Access Compliance Report

Public Rights-of-Way

Intersection ID: 44472	Main Street: COREY_COMMON_AV	Cross Street: PRESTBURY_BV	Location:	N
ADA ID: 3E3935EFA595	Ramp Type: BlendTrans1	Initial Pass/Fail: Pass	Overall Compliance: No	Severity Score: 2.5

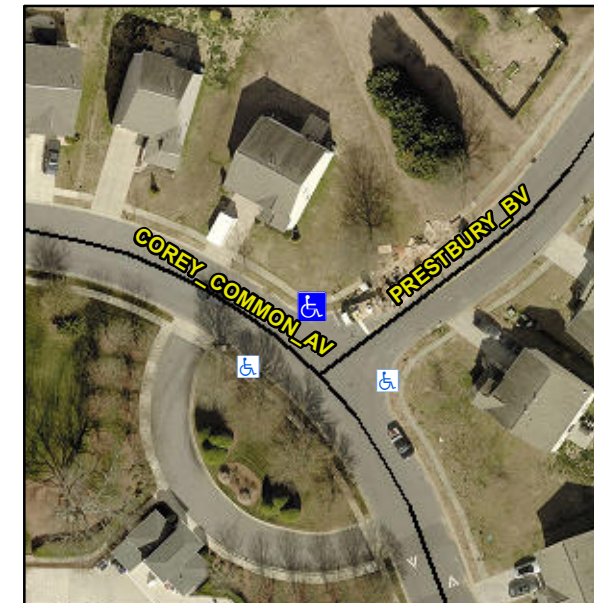
Not Found, R304.2.1, R305.1.4, R305.2

Remove & Replace Curb Ramp With Two New Directional Ramps or Equivalent.
